SITE PLAN

SOIL/SITE EVALUATION for ON-SITE WASTEWATER SYSTEM

IMPROVEMENT PERMIT DENIAL

Re: Application for Improvement Permit for property located at 4509 WOODLAND AV , MINT HILL, NC 28227
Parcel No.: 13711270
Health Department File No.: SP26-097

PROPOSED PLOT PLAN

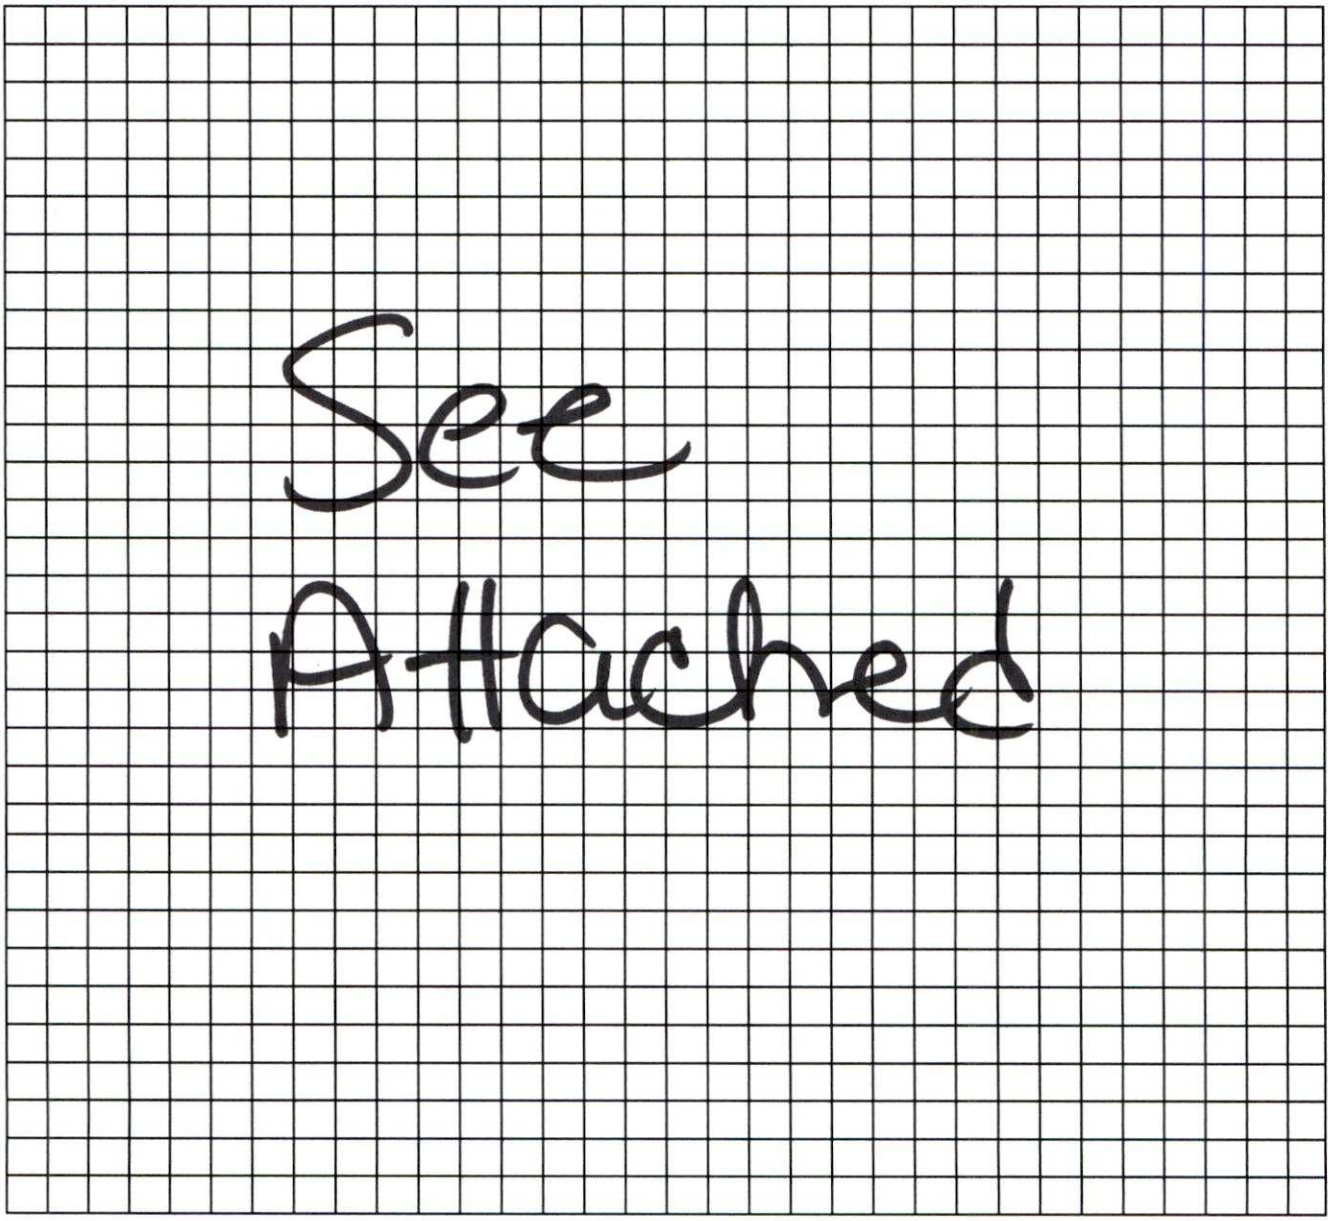
COMMENTS: There is insufficient space for a 5 BR SFR initial system and repair area with a design LTAR of 0.30.

Based on the criteria set out in 15A NCAC 18E .0501 through .0602, the evaluation indicated that the site is **UNSUITABLE** for an on-site wastewater system. Therefore, we must deny your request for an Improvement Permit. A copy of the site evaluation is enclosed. The site is unsuitable based on the following:
